**ADDENDUM  
NO. 4**

**November 9, 2021**

**CROWN POINT HIGH SCHOOL ADDITIONS AND RENOVATIONS  
Crown Point, IN 46307**

## ADDENDUM FOUR

© GIBRALTAR DESIGN SHEET  
**C-1.2**

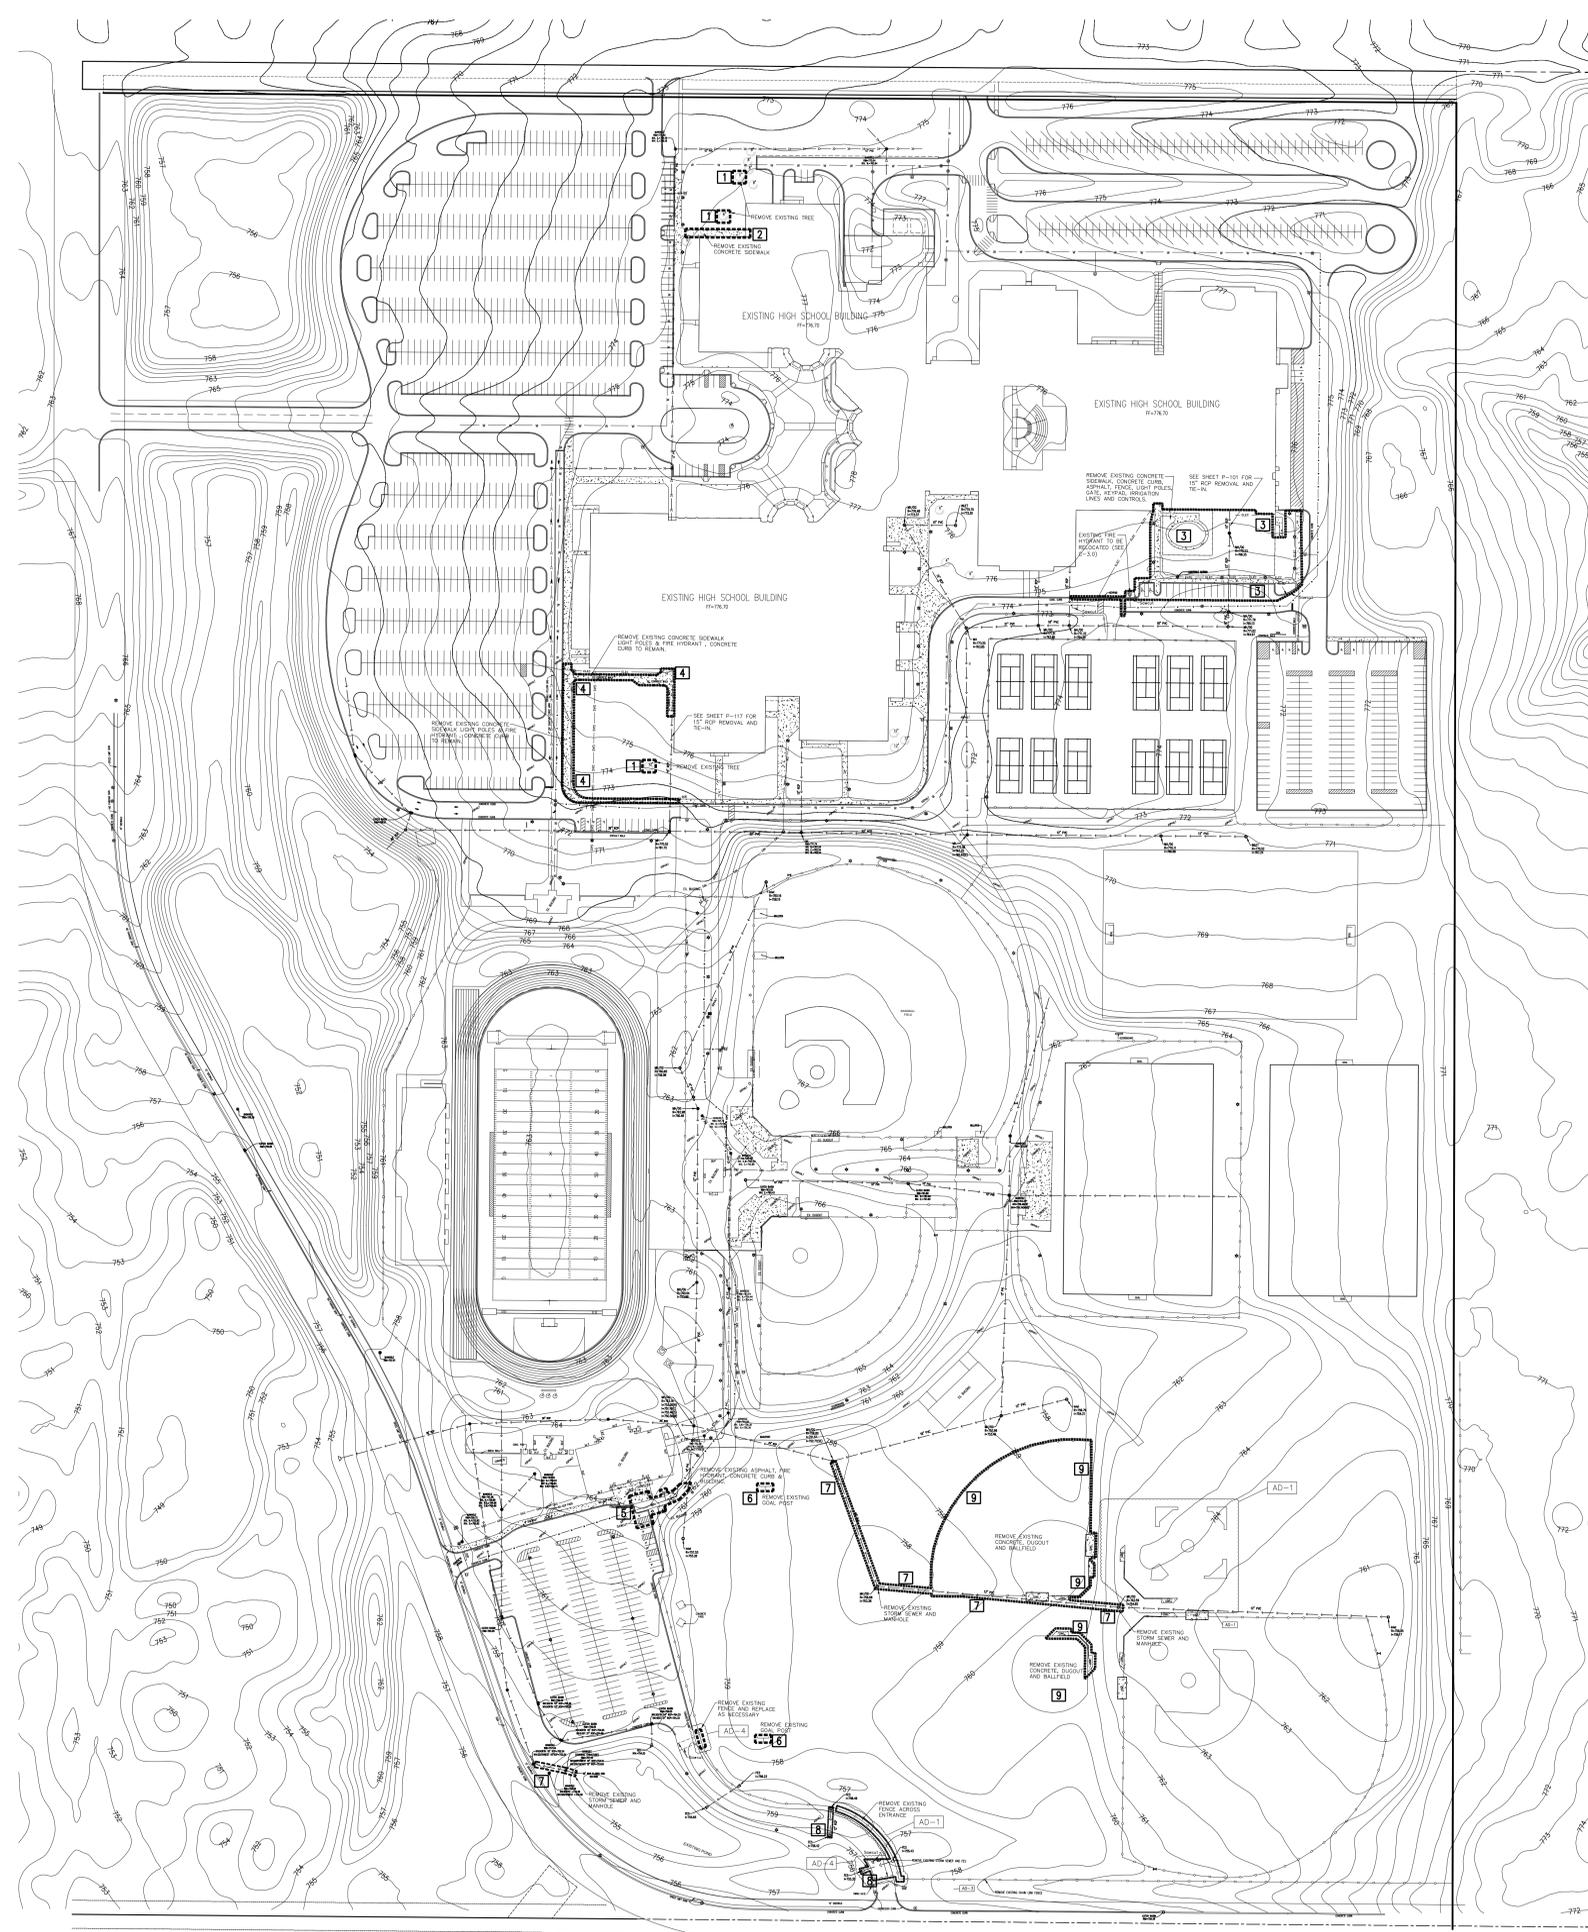
Reference Note 3 on drawing sheet C-1.2; **The Bid Category No. 1 Contractor** shall include removal of the existing playground equipment to be turned over to the owner.

1. **Sheet C-1.2**
  - A. Refer to full size Sheet included with this addendum - Demolition – Additional asphalt removal and fence removal along southern entrance Road.

© GIBRALTAR DESIGN SHEET  
**C-3.1**

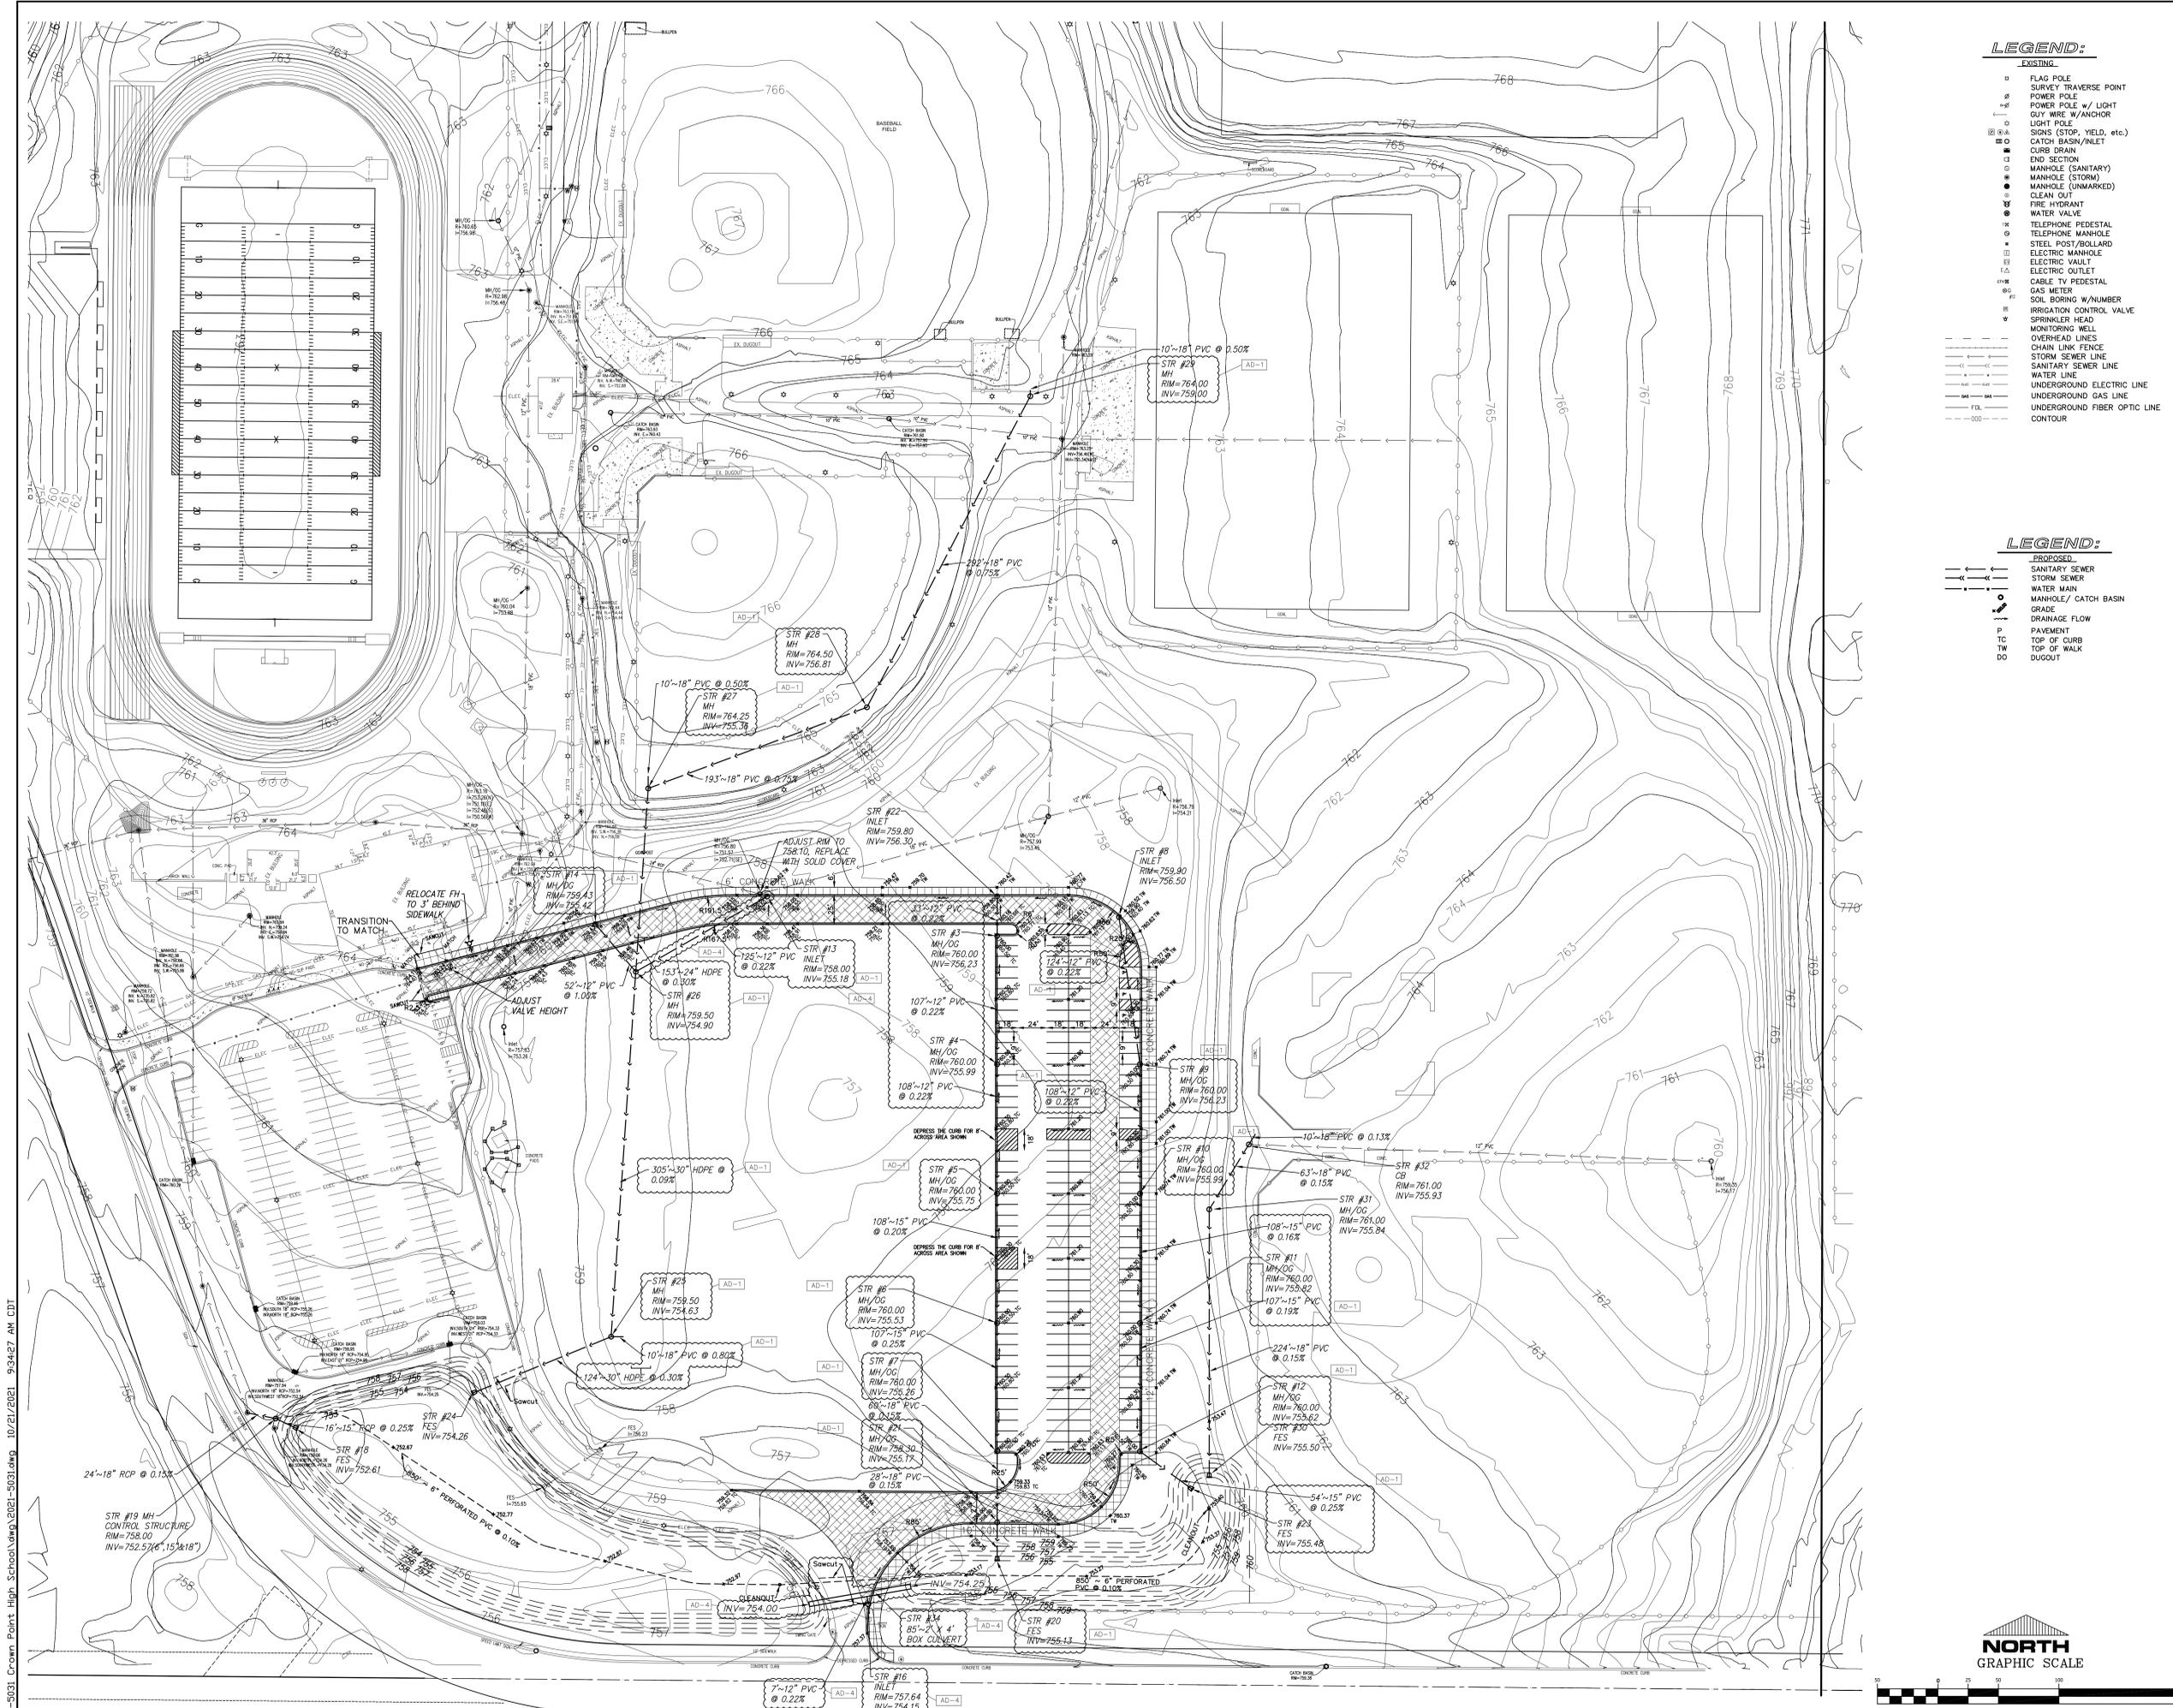
- A. Refer to full size Sheet included with this addendum - Grading, Storm Sewers, Sanitary Sewers & Water Main Plan – A larger depiction of C-3.0.

**C4.0**

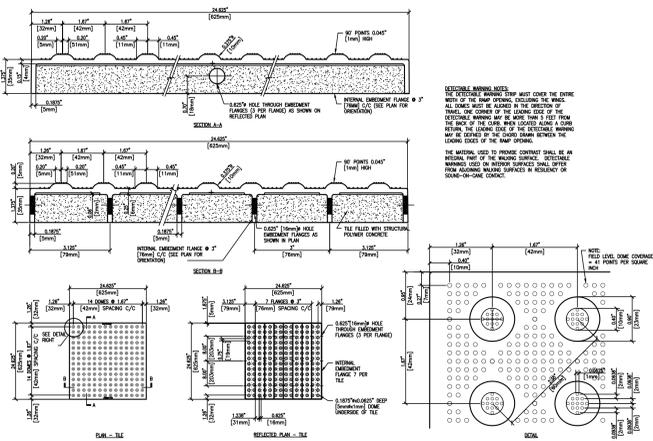
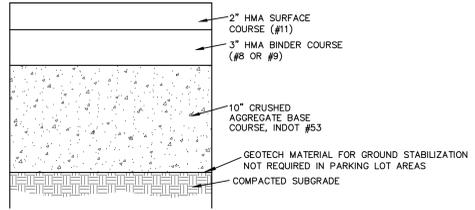
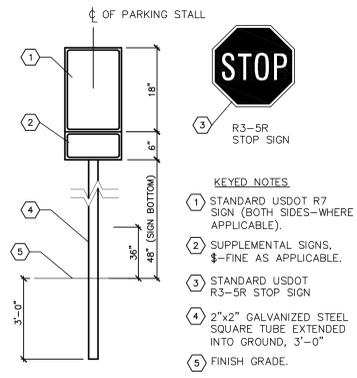
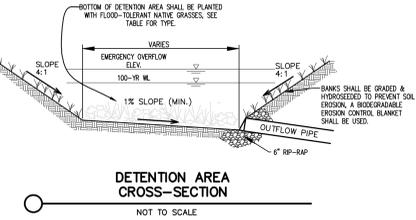
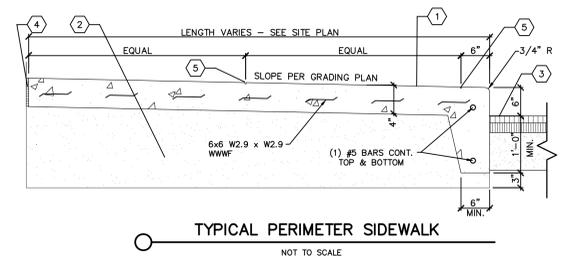
- A. Refer to full size Sheet included with this addendum - Details & Specifications – New note under "SPECIFICATIONS FOR STORM SEWERS" has been added.

- All storm sewer installed under pavement shall be SDR26 grade.

GIBRALTAR DESIGN SHEET  
**C-5.0**

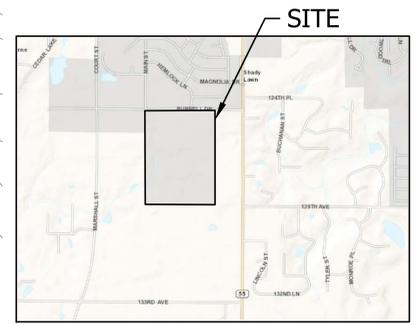
- A. Refer to full size Sheet included with this addendum - Master Storm Water Pollution Plan – Construction – Location of the concrete washout has been moved.
